INSPECTION REPORT

Docket No.: 72-1007

Inspection Report: 72-1007/97-212

Certificate Holder: Sierra Nuclear Corporation

Photo #4

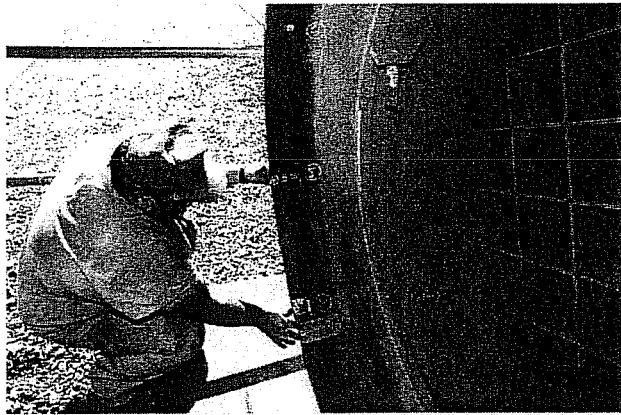
Photograph #4 illustrates the positions of the samples taken from AMSB-009 which were subsequently sent for analysis.

Photo #9

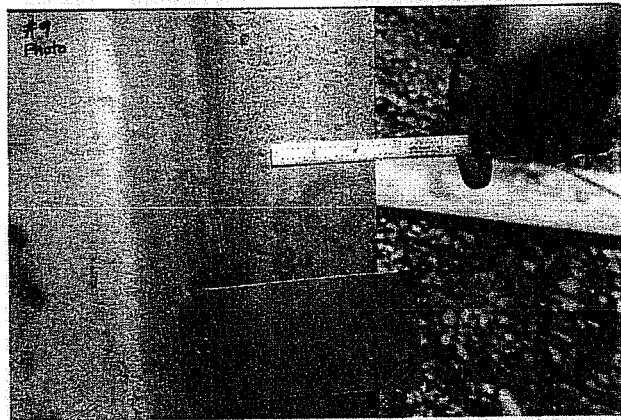
The circular indications on photographs #9, #14, and #14A were found by nitric acid etching of the surface and are weld fusion areas. These are typical of indications found on other empty MSB's currently on site. The largest circular indications are typically 61-63 inches from the zero circumference mark, are approximately an inch from the edge, and are approximately 1.6 inches in diameter. The shape of the other weld fusion regions vary from circular to more elongated and irregular, with a "C" shape on several.
